PRODUCT SERVICE BULLETIN

Bulletin Number: PSB 01-2015

**Subject: Vigil Cutters manufactured March 2015 – July 2015
(03/2015 – 07/2015)**

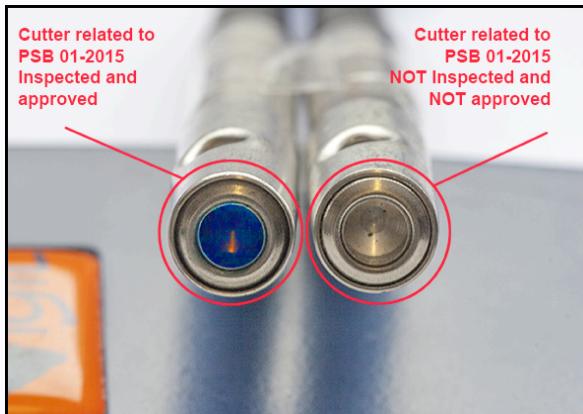
Upon investigating a report of a severed closing loop, it was determined that a rough edge inside the cutter abraded the loop fabric, causing it to fail.

Inspection of other cutters revealed a limited range of cutters which could potentially have rough edges inside. Subject cutters appear to be more likely to abrade the closing loop in equipment where the cutter is placed above the pilot chute. We do not expect to find that every cutter in this range of cutters has an issue, but in the interest of safety we are requiring that every cutter in this range be inspected.

A.A.D. nv/sa has determined that all cutters identified as having been produced during the specified date of manufacture range (3-15, 4-15, 5-15, 6-15 and 7-15) (mm-yy), whether or not they are installed in a harness-container-AAD system, must be recalled for in-house microscopic inspection at A.A.D. nv/sa, and that all reserve container closing loops with which a subject cutter was used must be replaced.

After inspection of the returned subject cutter by A.A.D. nv/sa, a blue paint dot will be placed on top of the cutter to indicate that the cutter has been inspected and approved by A.A.D. nv/sa. A cutter will be returned, which will be accompanied by a new service card, dated and signed with a special stamp, confirming the inspection of the cutter.
